ORIGINATION FORM

Proposed Revisions to a Standard Plans Index

Index Number: 102-606

Two-Lane Roadway, Lane Closure Using
Temporary Traffic Signals

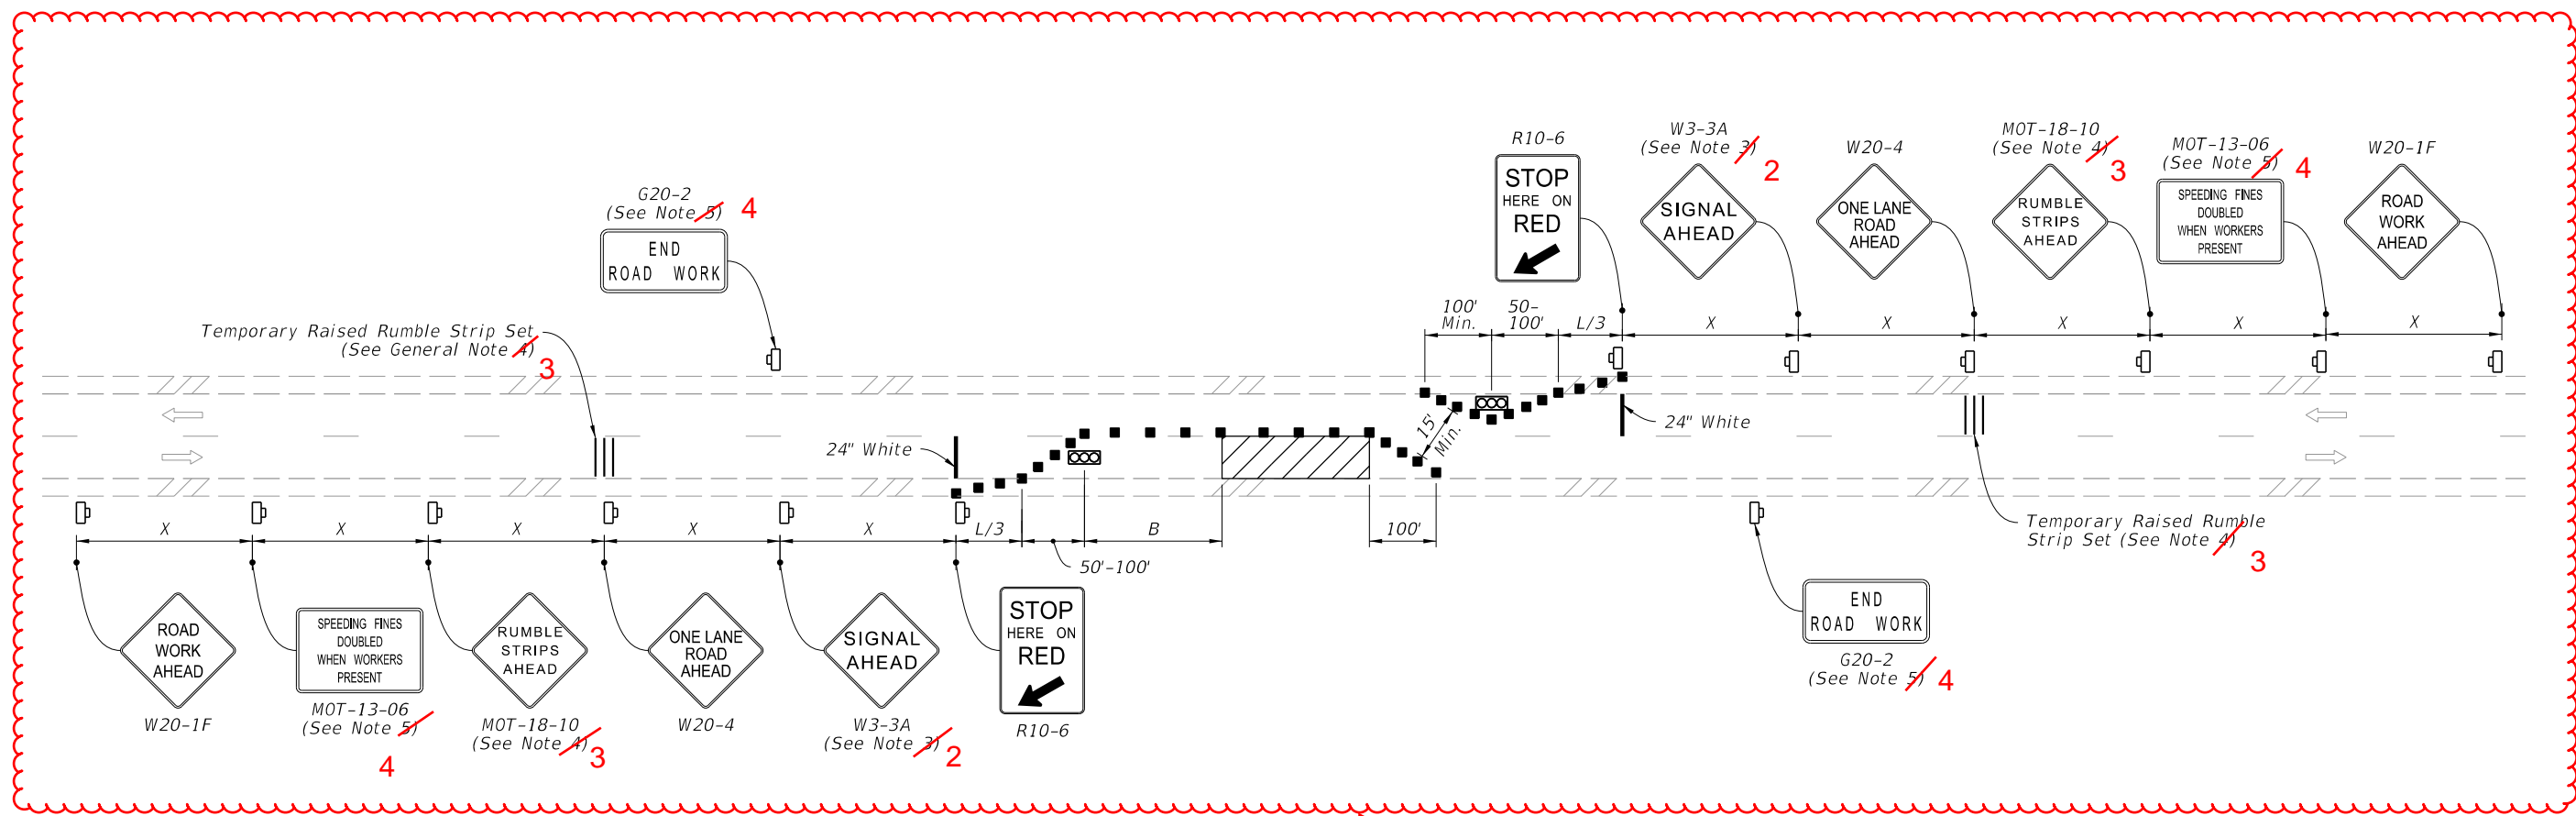
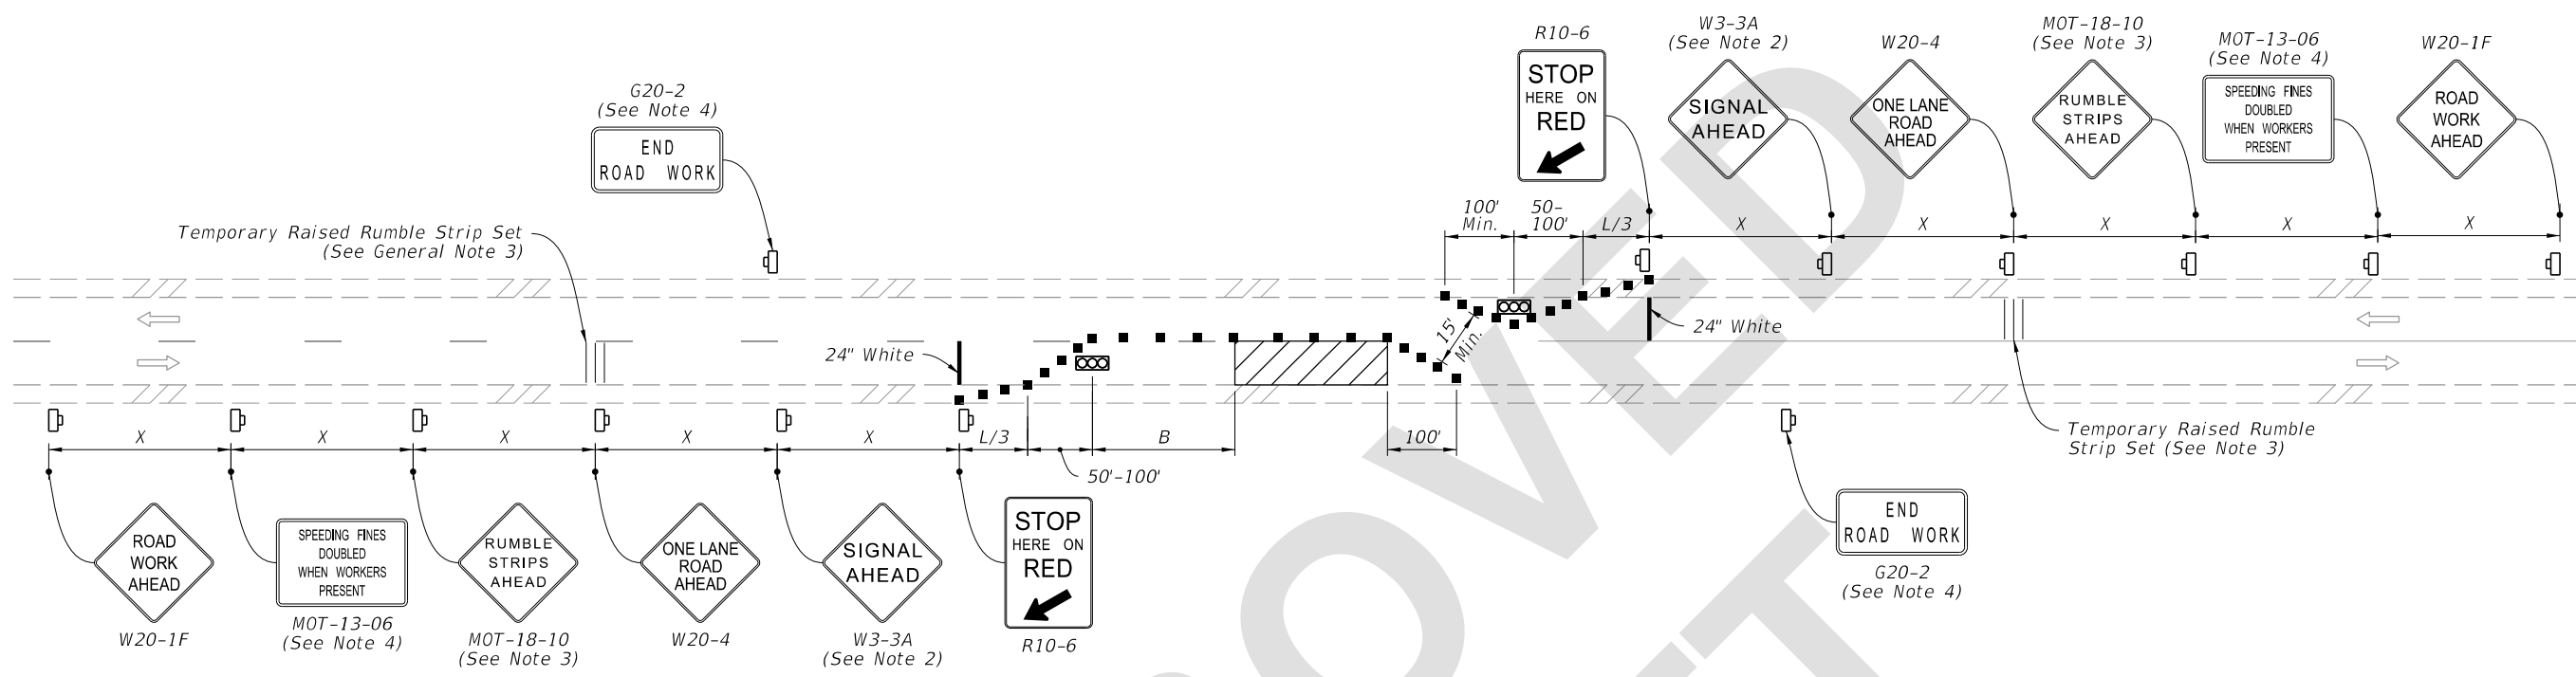
Sheet 1: Deleted Note 2 "District Traffic Operations Engineer must approve the installation and timing of temporary signals modifications prior to beginning of work. Adjust timing based on changing field conditions as approved by the Worksite Traffic Supervisor. Obtain approval from the District Traffic Operations Engineer for any timing changes that are either reoccurring or last longer than 24 hours". This note has been added to Specification 102-9; Updated the Note callouts references in the details; Deleted the Flagger from the Symbols.

UPDATED NOTE REFERENCES

DELETED NOTE 2 and ADDED to Specification 102-9

Renumbered

Renumbered

DELETED

The note was moved to the Specifications to provide guidance to the contractor in one area for all temporary signal timing.
